# ALERT SERVICE BULLETIN

**SUBJECT:** MAIN ROTOR SYSTEM - Main Rotor Head

Rework of the hub cap

Revision No.	Date of issue
Revision 0	2017-04-04

Figure 1

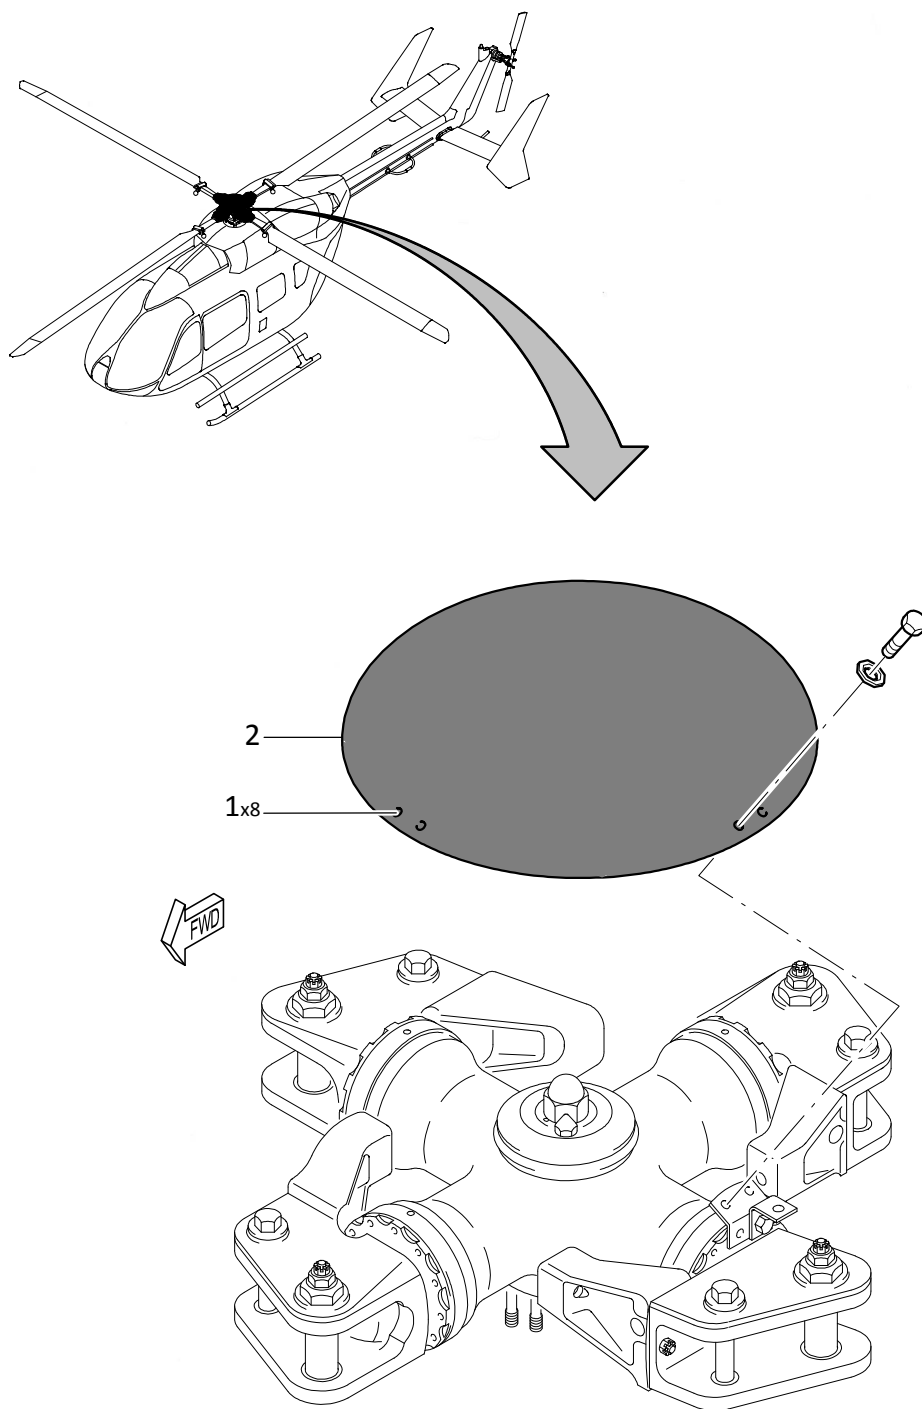
The rework improves the hub cap installation on the main rotor head. The increased bore diameter of all drillings enables a more stress free installation of the hub cap and therefore reduces the risk of cracks in the mounting brackets.

1. Drill the eight boreholes (1, Fig. 1) to dia. 8.0 mm.
2. Deburr boreholes (1, Fig. 1).
3. Apply EP primer (CM 436, CM 459, CM 472) to boreholes (1, Fig. 1).
4. Let EP primer dry i.a.w. the manufacturer's instructions.
5. Degrease the area close to the P/N of the hub cap (2, Fig. 1) using dry cleaning solvent (CM 202).
6. Using a permanent pen, identify the hub cap as follows: "ASB MBB-BK117 C-2-62A-010".
7. Protect identification using lacquer, single layer (CM 421) and leave it to dry i.a.w. the manufacturer's instructions.

- 1 Borehole      dia. 8.0 mm  
2 Hub cap
